ISSUE: Certificate of Appropriateness for alterations

APPLICANT: David and Anne Ayres

LOCATION: Old and Historic Alexandria District
401 Duke Street

BAR #2021-00019
401 Duke Street

PERGOLA PLAN

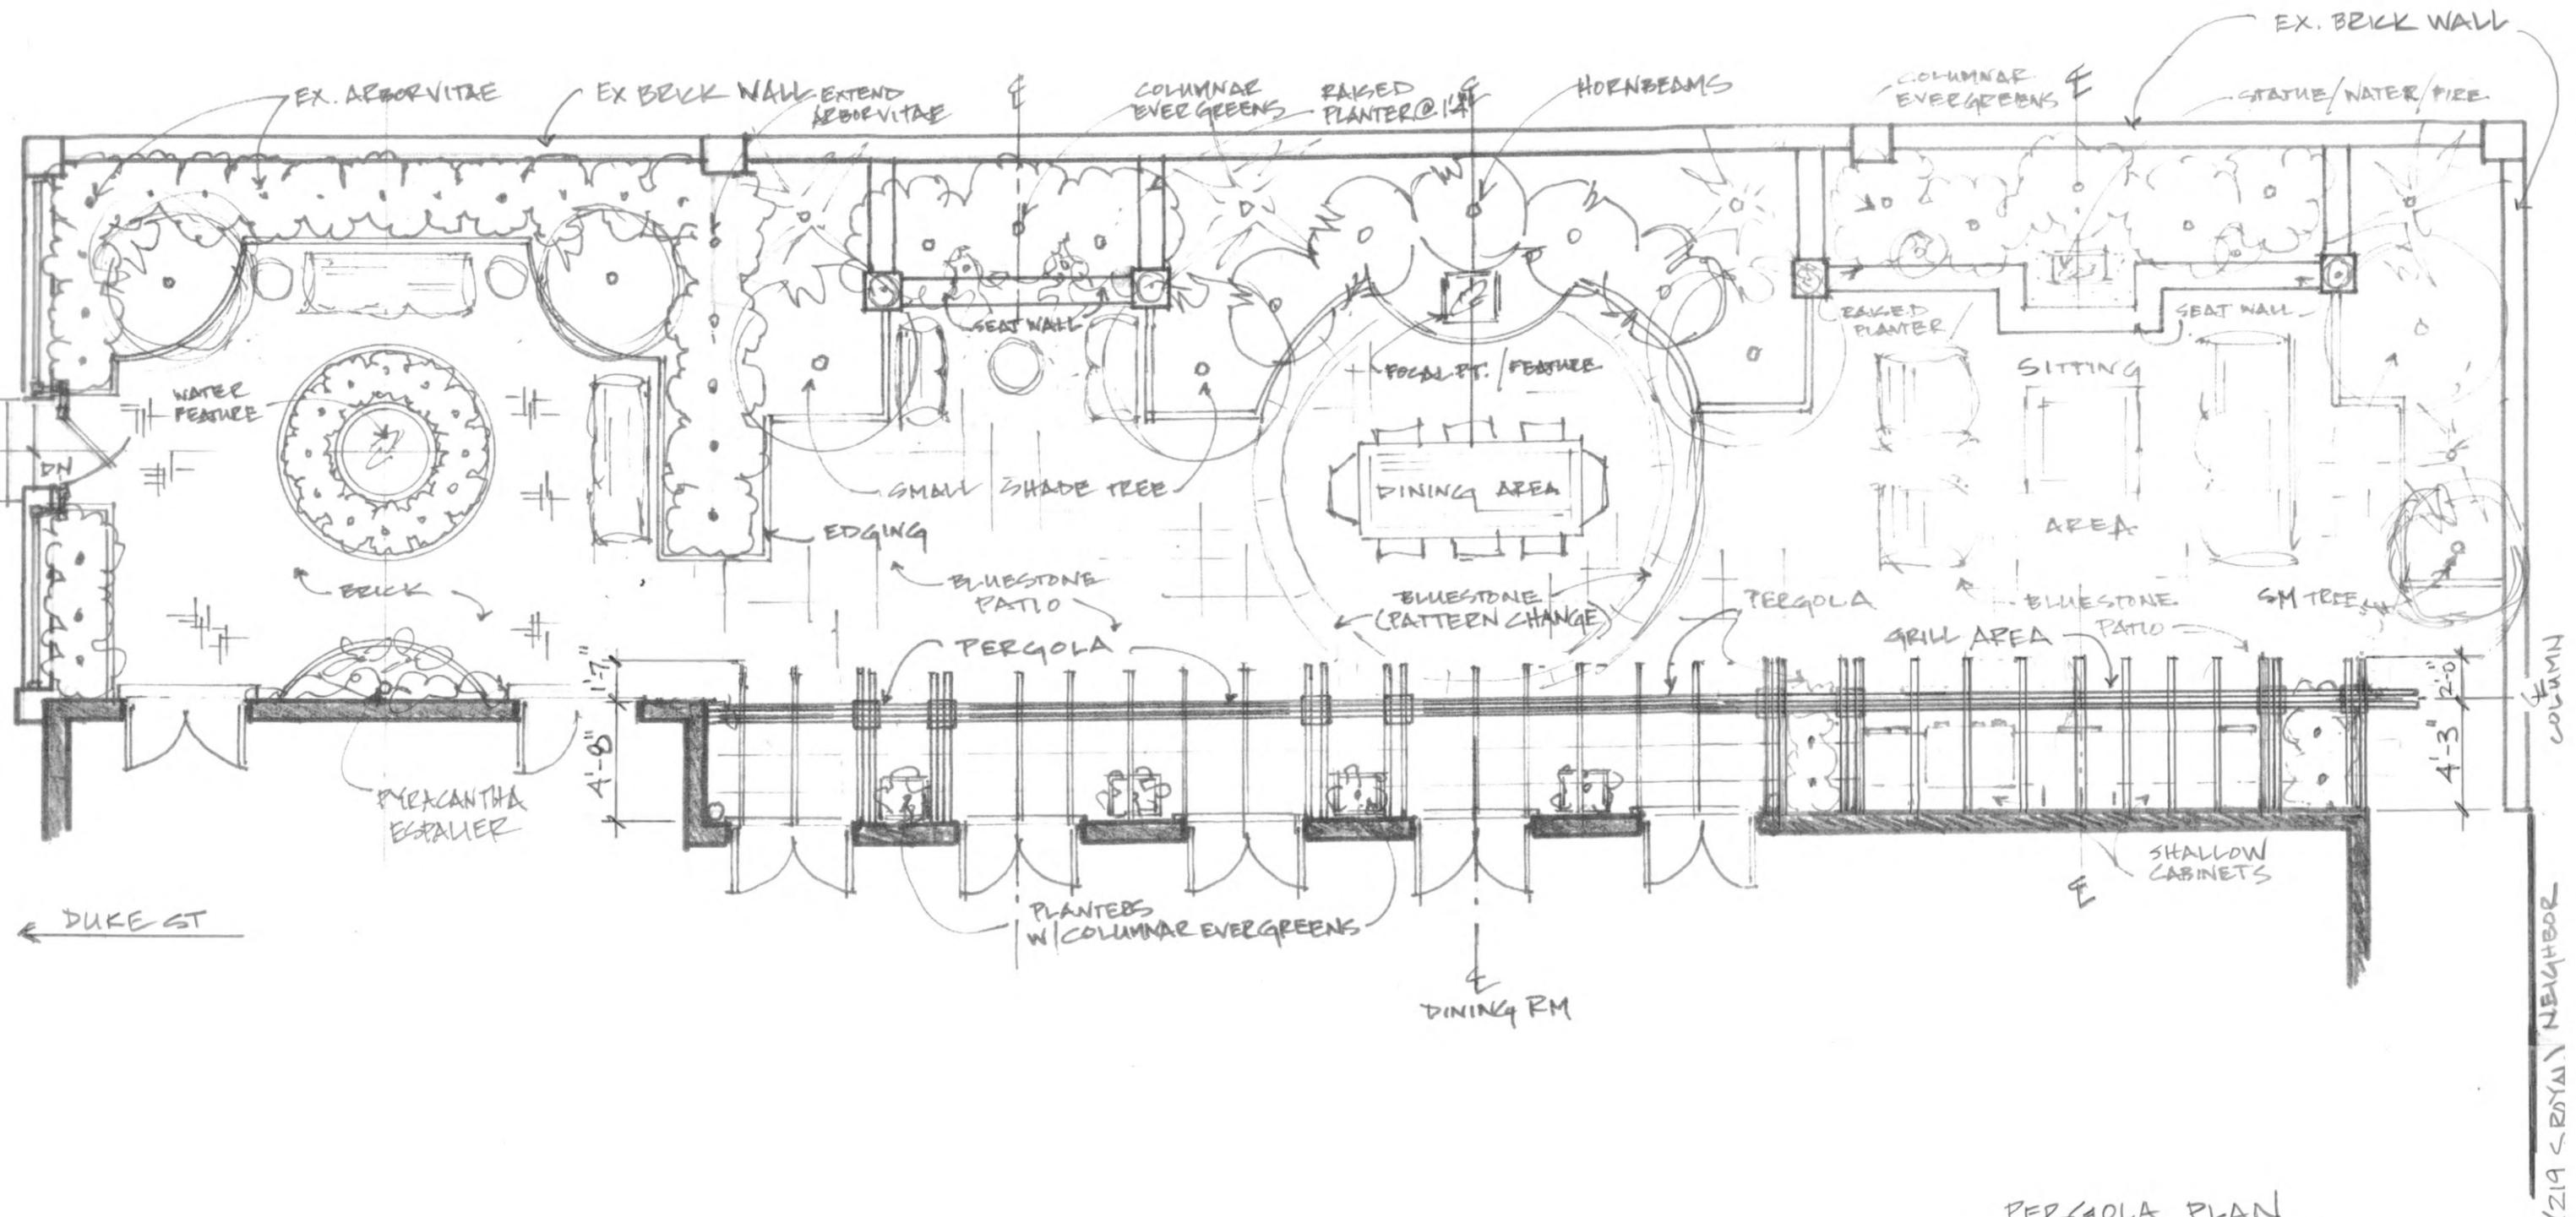
The pergola is well designed and creates an inviting outdoor space for the homeowners. The *Design Guidelines* does not contain a chapter on outdoor features such as pergolas, trellises or arbors but staff finds the proposed pergola to be modest and compatible with this late 20th century home. Staff recommends approval of the application, as submitted.

F-1 The pergola is 80% open and less than 10 feet tall, therefore it meets the requirements of 7-202(A)(5) and may be located in the required rear yard.

F-2 The proposed pergola complies with zoning.
